CEC Blatchington Road, Brighton

Structural Feasibility Report

Client Name: CO-OP GROUP
Document Reference: STR19319-WAT-ZZ-ZZZ-RP-S-001
Project Number: STR19319

TA XYZ / 10

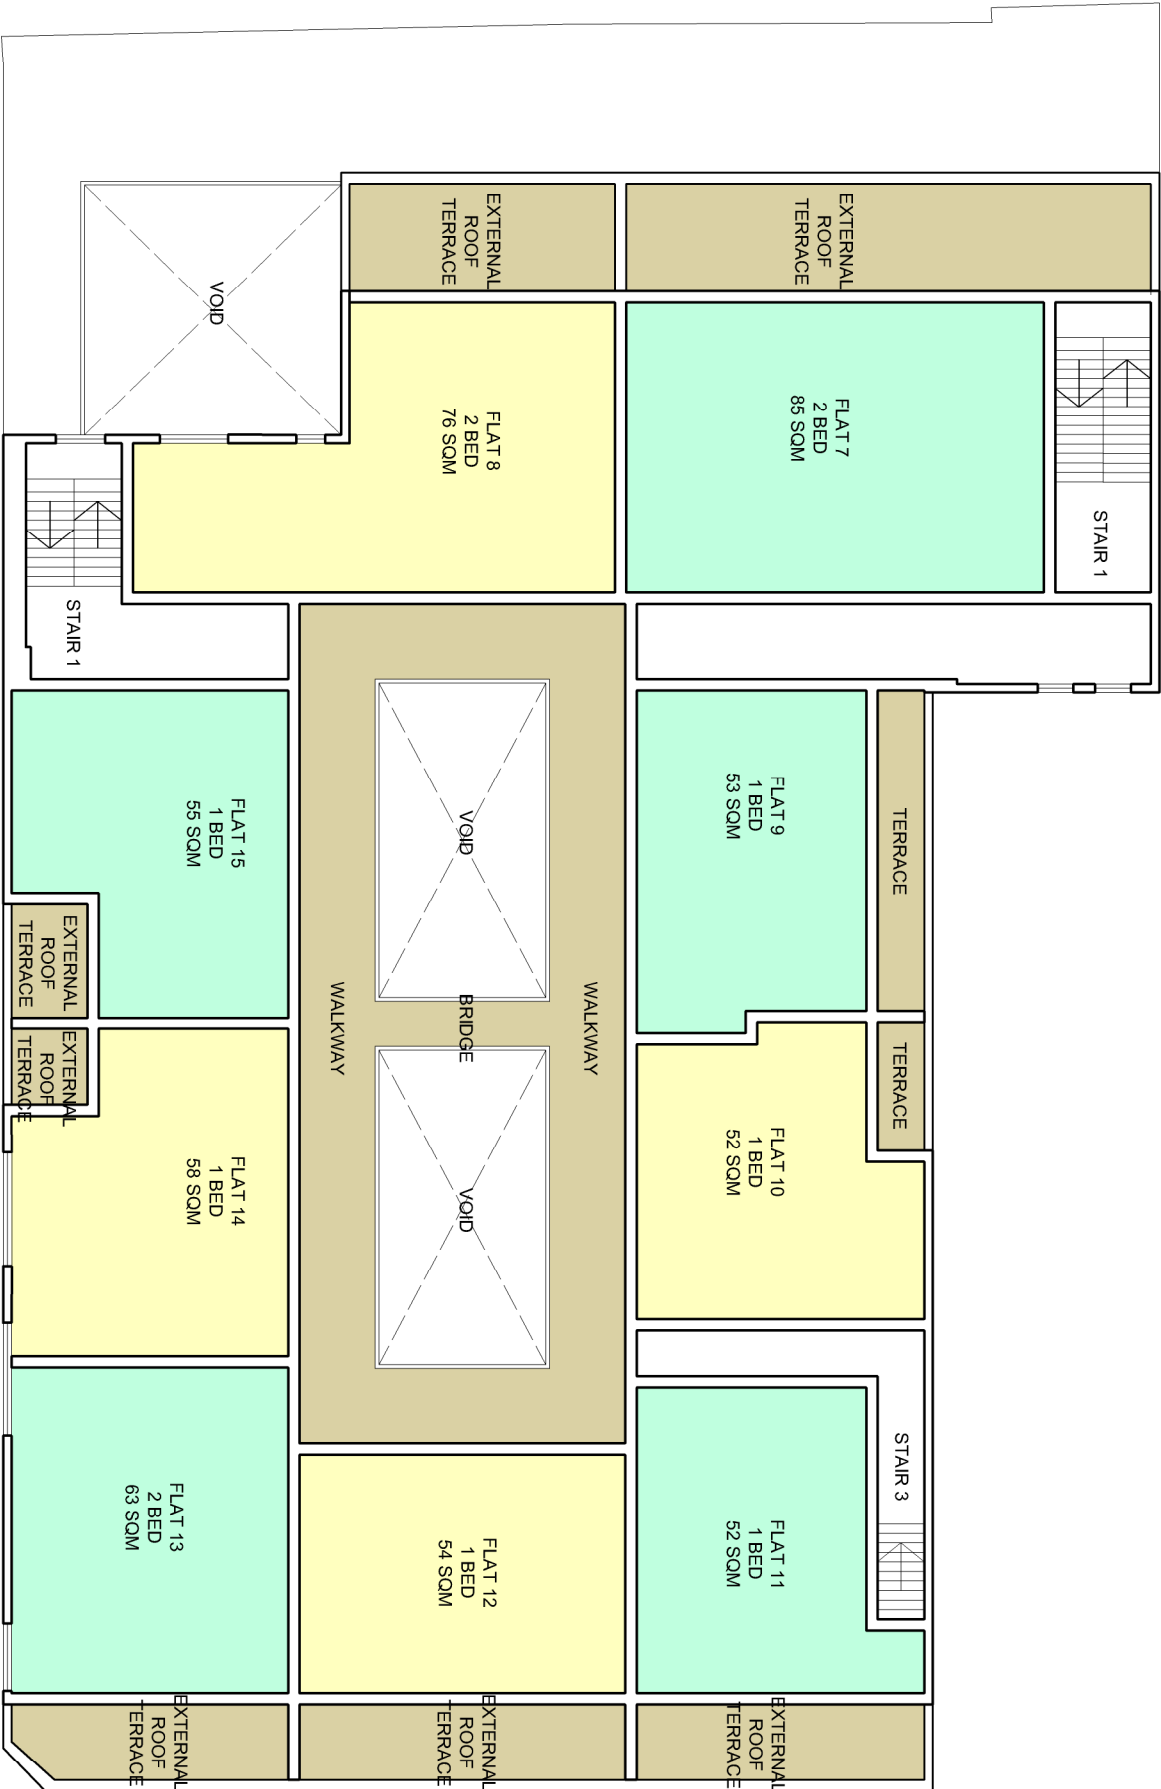
- 5No residential flats are being proposed on the first floor as indicated by Turner Associates on drawing no. TA XYZ/10. The flats are located around the periphery of the building footprint with a large internal area allocated for communal terrace with light wells/sky lights above. The flats are indicated to have individual inset terraces.
- On the proposed drawing referenced above, a number of columns have not been shown. These will need to be reflected on the proposed plans and the new general arrangement updated to suit the existing column locations.

drawing
Proposed first floor plan

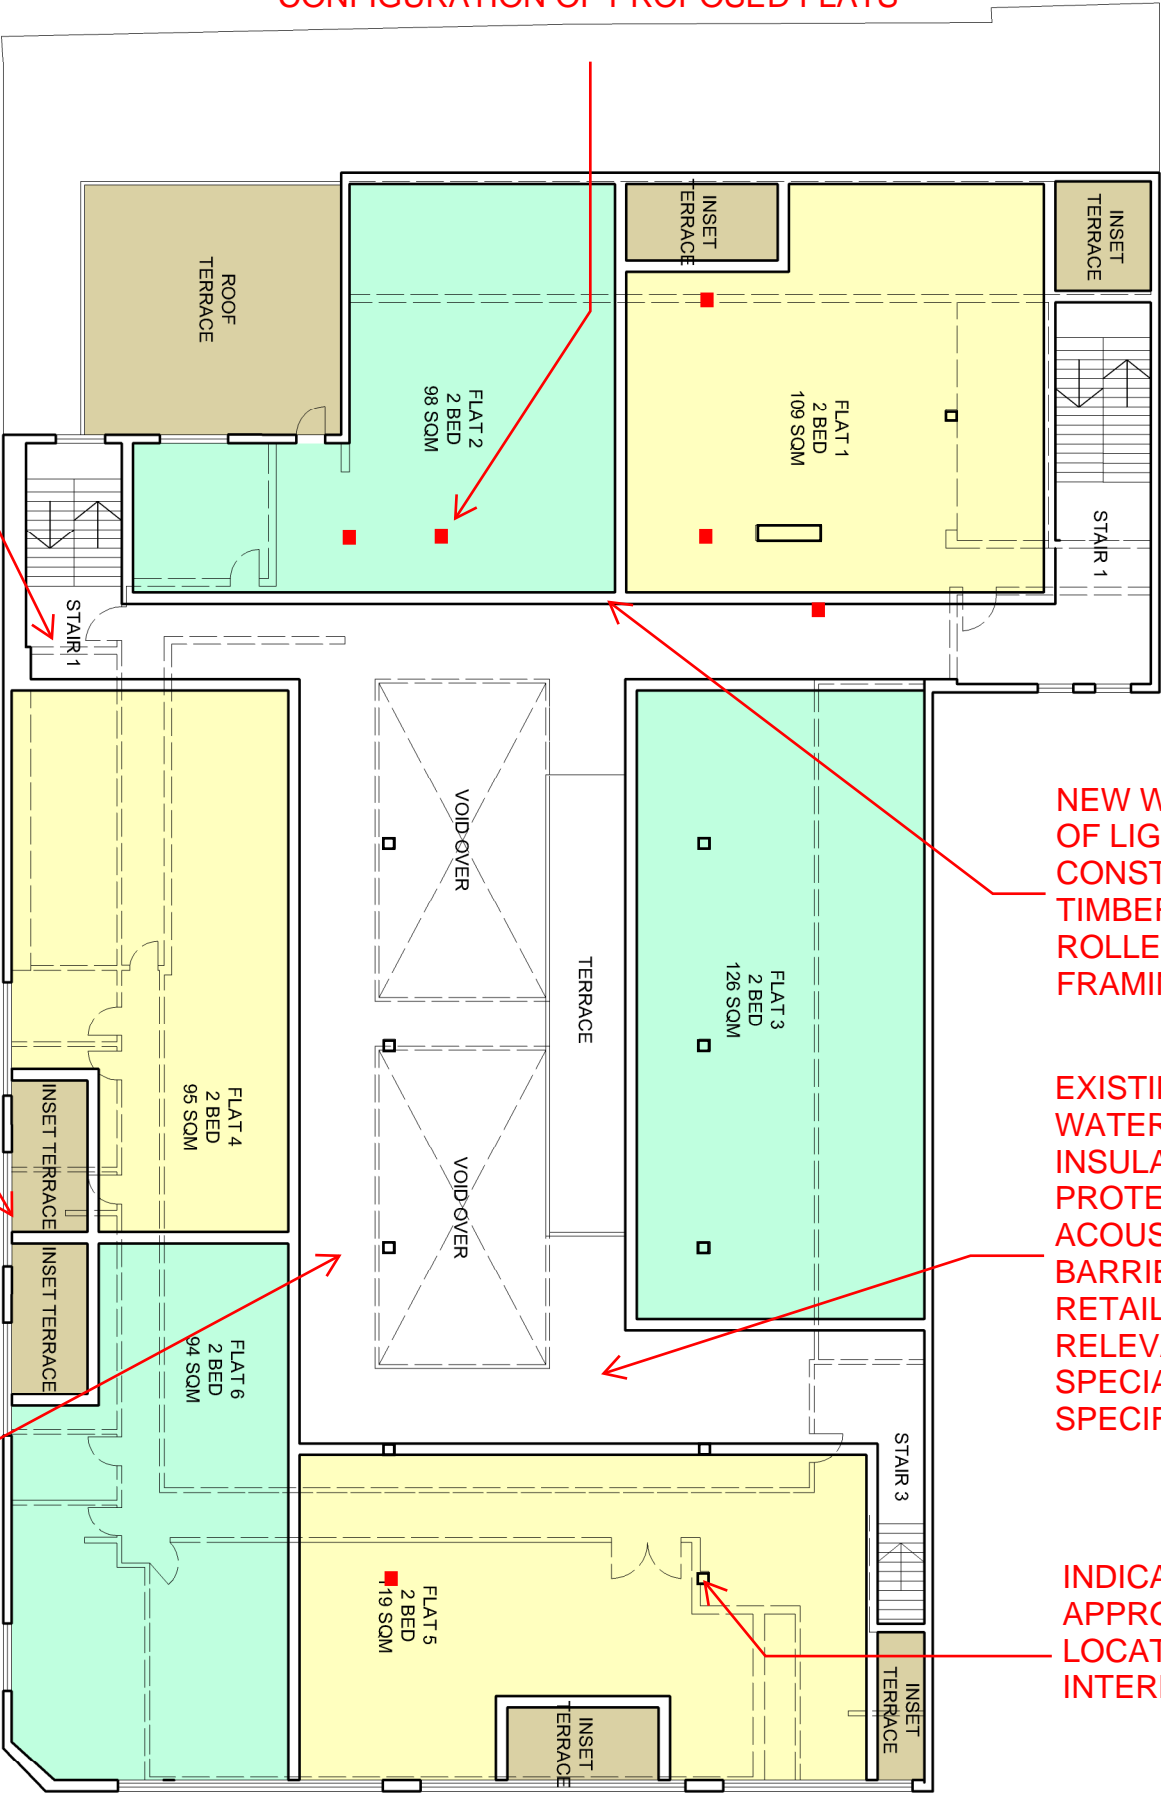
PROPOSED FLOOR PLAN DOES NOT TAKE INTO ACCOUNT ALL INTERNAL COLUMNS AS APPROXIMATELY INDICATED IN RED. LOCATION OF COLUMNS WILL AFFECT CONFIGURATION OF PROPOSED FLATS

NEW WALLS TO BE OF LIGHTWEIGHT CONSTRUCTION I.E. TIMBER OR COLD ROLLED SFS FRAMING SYSTEM

EXISTING FLOOR TO BE WATERPROOFED, INSULATED, FIRE PROTECTED AND ACOUSTICALLY BARRIERED FROM THE RETAIL FLOOR BELOW RELEVANT SPECIALISTS SPECIFICATIONS

MASONRY AROUND ALL STAIR CORE (3No.) MAY BE LOAD BEARING. THIS IS TO BE DETERMINED THROUGH FURTHER INTRUSIVE INVESTIGATION

ALL NEW WINDOW OPENINGS WILL REQUIRE NEW LINTELS AND ASSOCIATED TEMPORARY WORKS

EXISTING SUPPORTING STRUCTURE TO BE ASSESSED FOR NEW LOADING - REFER TO WSL REPORT REFERENCED STR19319-WAT-ZZ-ZZZ-RP-S-001 CEC BLATCHINGTON ROAD

drawing
Proposed second floor plan
scale 1:200@A3 date Dec 2023 drawn nm

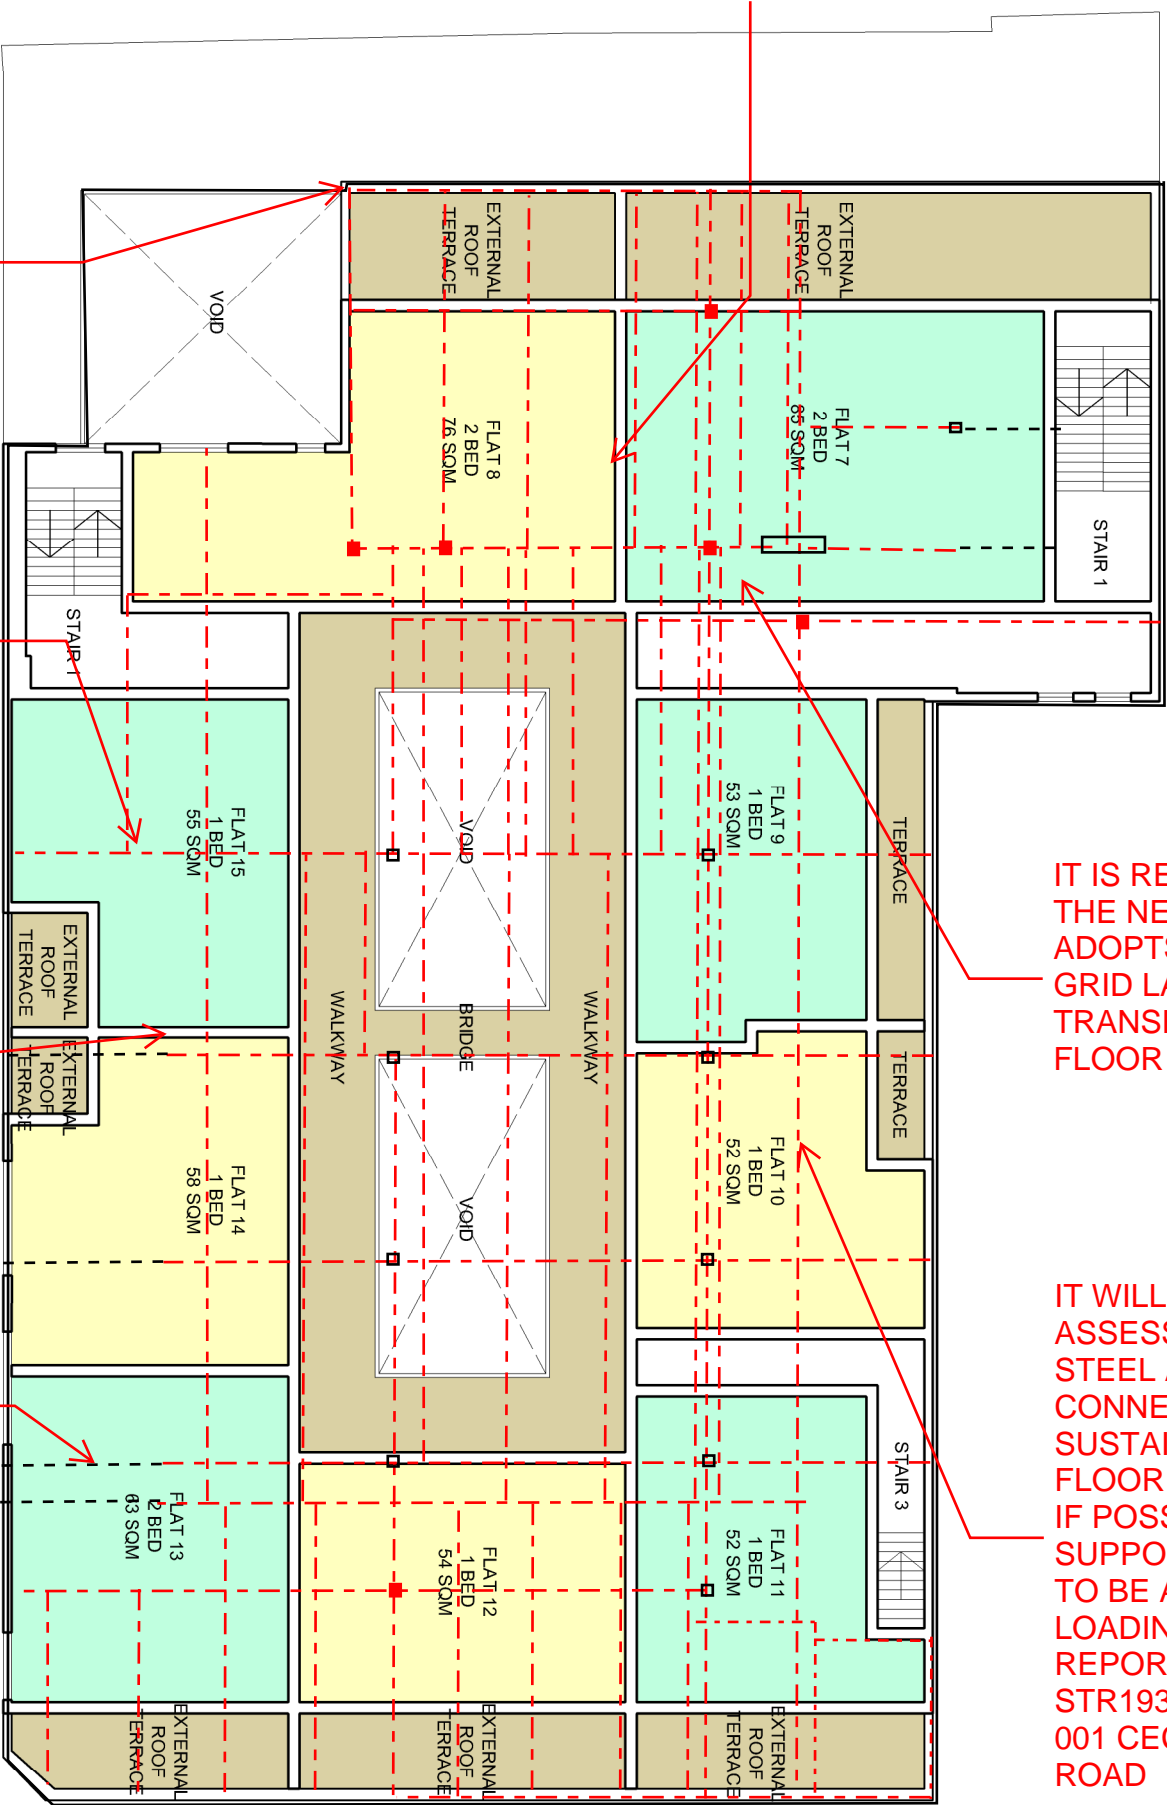
PROPOSED FLOOR PLAN DOES NOT TAKE INTO ACCOUNT ALL INTERNAL COLUMNS. REFER TO WSL SITE SURVEY SKETCH FOR APPROXIMATE LOCATIONS. LOCATION OF COLUMNS WILL AFFECT CONFIGURATION OF PROPOSED FLATS

IT IS RECOMMENDED THAT THE NEW SECOND FLOOR ADOPTS THE SAME COLUMN GRID LAYOUT TO AVOID TRANSFER BEAMS ON FLOOR BELOW

IT WILL BE PRUDENT TO ASSESS WHETHER EXISTING STEEL AND STEEL CONNECTIONS COULD SUSTAIN NEW SECOND FLOOR LOAD AND RETAINED IF POSSIBLE. EXISTING SUPPORTING STRUCTURE TO BE ASSESSED FOR NEW LOADING - REFER TO WSL REPORT REFERENCED STR19319-WAT-ZZ-ZZZ-RP-S-001 CEC BLATCHINGTON ROAD

ALL COLUMNS ON PERIMETER WALLS TO BE ASCERTAINED ON SITE FOLLOWING FULL STRIP OUT

drawing
Proposed second floor plan
scale 1:200@A3 date Dec 2023 drawn nm

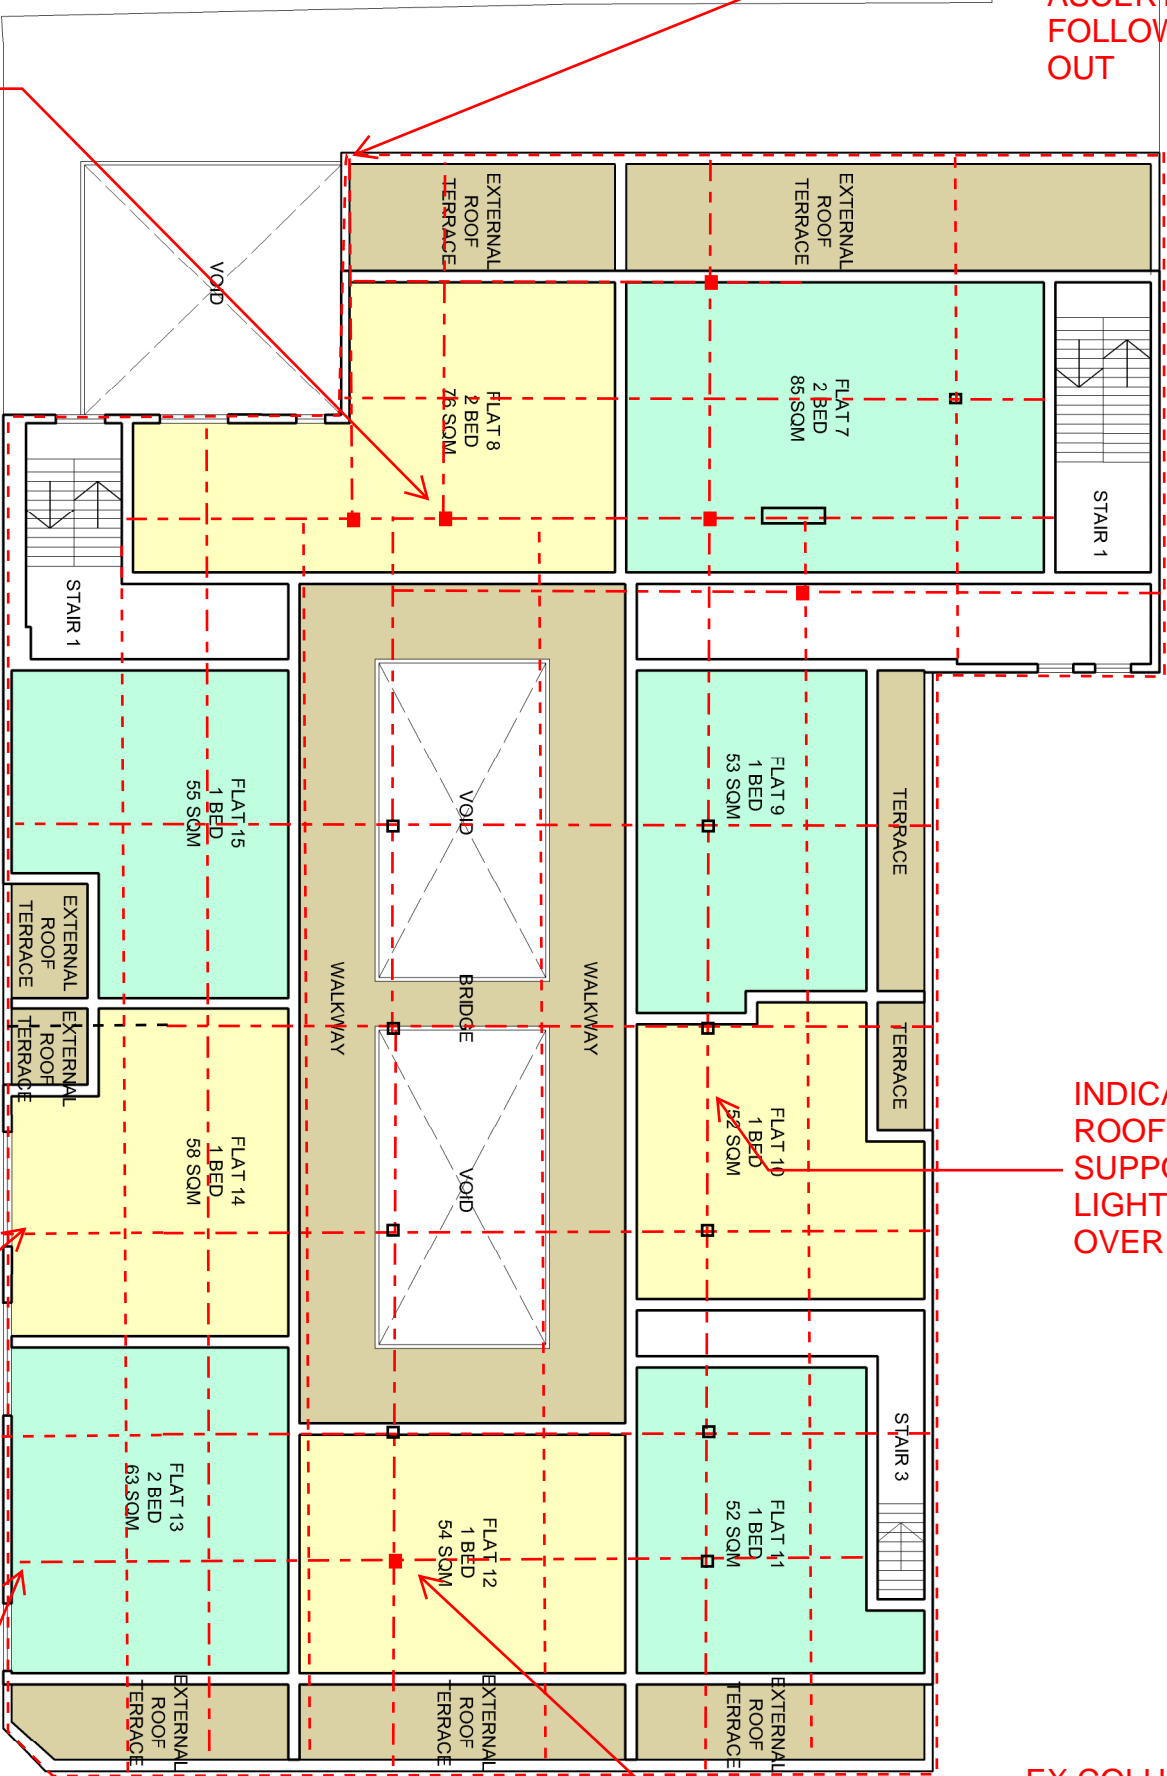
NEW WALLS TO BE OF LIGHTWEIGHT CONSTRUCTION I.E. TIMBER OR COLD ROLLED SFS FRAMING SYSTEM

ALL COLUMNS ON PERIMETER WALLS ON FLOOR BELOW TO BE ASCERTAINED ON SITE FOLLOWING FULL STRIP OUT

INDICATIVE STEEL GA AT ROOF LEVEL TO SUPPORT NEW LIGHTWEIGHT ROOF OVER SECOND FLOOR

EX COLUMNS EXTENDED TO ACCOMMODATE NEW SECOND FLOOR

IT IS RECOMMENDED THAT THE NEW SECOND FLOOR ADOPTS THE SAME COLUMN GRID LAYOUT TO AVOID TRANSFER BEAMS ON FLOOR BELOW AND THE NEW ROOF SUPPORTED ON STEELS ON COLUMNS EXTENDED FROM THE FIRST FLOOR SUBJECT TO FURTHER ASSESSMENT

NEW SECOND FLOOR TO ADOPT LIGHTWEIGHT CONSTRUCTION TECHNIQUES I.E TIMBER FRAME, SFS FRAMING SYSTEM

EXISTING SUPPORTING STRUCTURE TO BE ASSESSED FOR NEW LOADING - REFER TO WSL REPORT REFERENCED STR19319-WAT-ZZ-ZZZ-RP-S-001 CEC BLATCHINGTON ROAD

LOCATION OF EXISTING COLUMNS ALONG THE PERIMETER TO BE EXTENDED UP TO 2ND FLOOR FOR NEW ROOF BEAM TO BE SUPPORTED
